Recall Bulletin

SUBJECT: Rear Axle Cross Pin Fracture

MODELS: 2011 Cadillac Escalade, Escalade ESV, Escalade EXT
2011 Chevrolet Avalanche, Colorado, Silverado, Suburban, Tahoe
2011 GMC Canyon, Sierra, Yukon, Yukon XL

Below are the revisions to the previous version of the bulletin, 10426C.

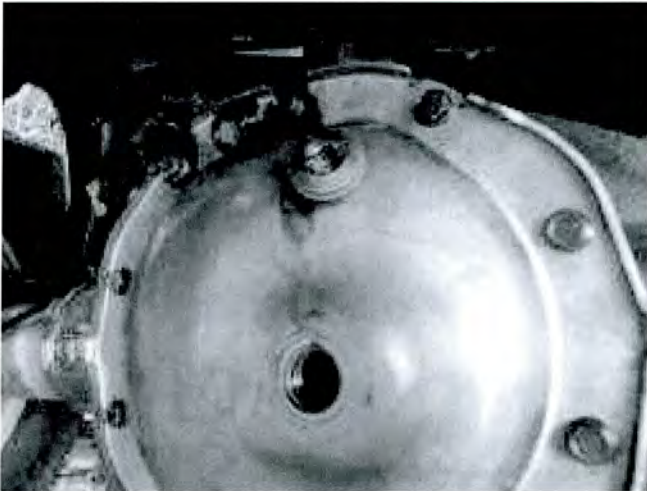
The inspection procedure in the Service Procedure section has been revised. If BOTH lines are not clearly visible on the cross pin, the cross pin must be replaced.

Note: If **BOTH** lines are not clearly visible on the cross pin, the cross pin **MUST** be replaced.

- If the head of the rear axle cross pin has orange and black paint marks or blue and black paint marks, do **NOT** replace the cross pin. Refer to illustration. Proceed to Step 14.
- If the head of the rear axle cross pin does **NOT** have a clearly visible orange and black paint mark, or a blue and black paint mark, (**BOTH** lines **MUST** be clearly visible), **REPLACE** the rear axle cross pin. Refer to illustration. Proceed to Step 10.

10. Remove the lock screw with a ratchet with a 5/16" hexagonal socket while holding the cross pin with a magnet. Dispose of the lock screw.

11. Remove the cross pin by pulling it with the magnet. Discard the cross pin.

12. Using a magnet, insert a new certified cross pin without moving the case position, aligning the cross pin hole with the lock screw hole.
